Economic Commission for Europe**Inland Transport Committee****World Forum for Harmonization of Vehicle Regulations****Working Party on Passive Safety****Fifty-eighth session**

Regulation No. 16 (Safety-belts)**Proposal for Supplement 7 to the 06 series of amendments to Regulation No. 16 (Safety-belts)****Submitted by the expert from the European Association of Automotive Suppliers ***

The text reproduced below was prepared by the expert from the European Association of Automotive Suppliers (CLEPA), to introduce provisions for a new fixture to verify space availability of universal lateral facing Child Restraint Systems (CRS) "lie-flat". It is based on a document without symbol (GRSP-57-07-Rev.1) distributed at the fifty-seventh session of the Working Party on Passive Safety (GRSP). The modifications to the current text of UN Regulation No. 16 are marked in bold for new or strikethrough for deleted characters.

Figure 7

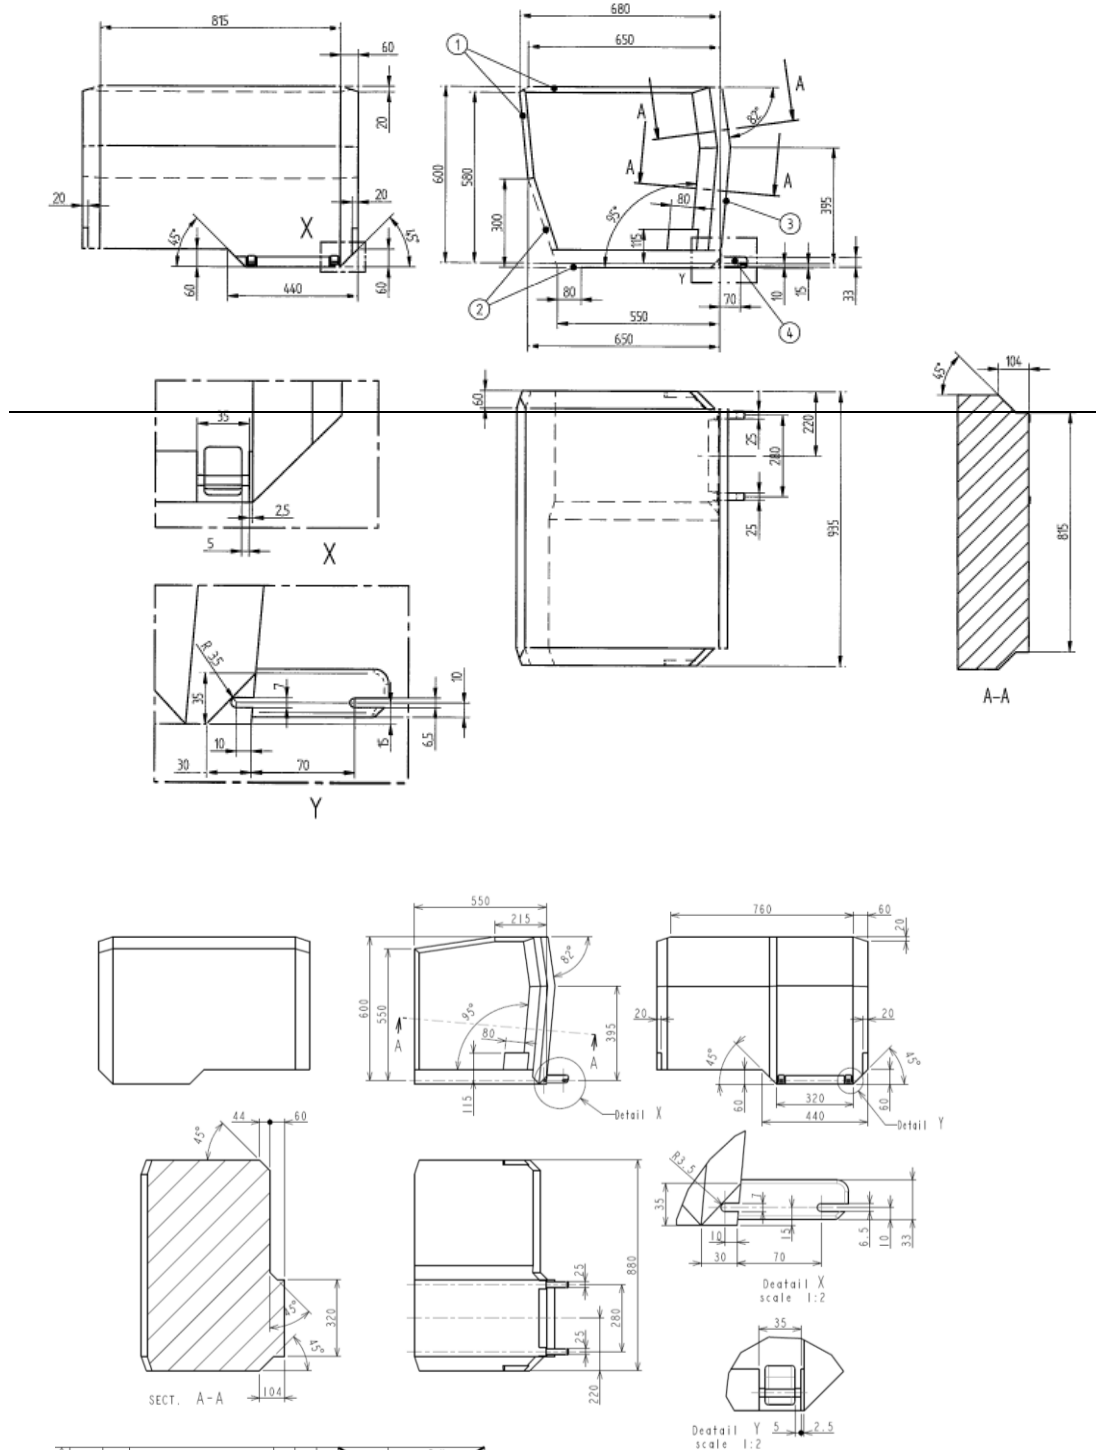
Paragraph 4.7., amend to read:

"4.7. Lateral facing child restraint systems envelope

Envelope dimensions for lateral facing position CRS – ISO/L1- ISOFIX SIZE CLASS F or symmetrically opposite – ISO/L2 – ISOFIX CLASS G
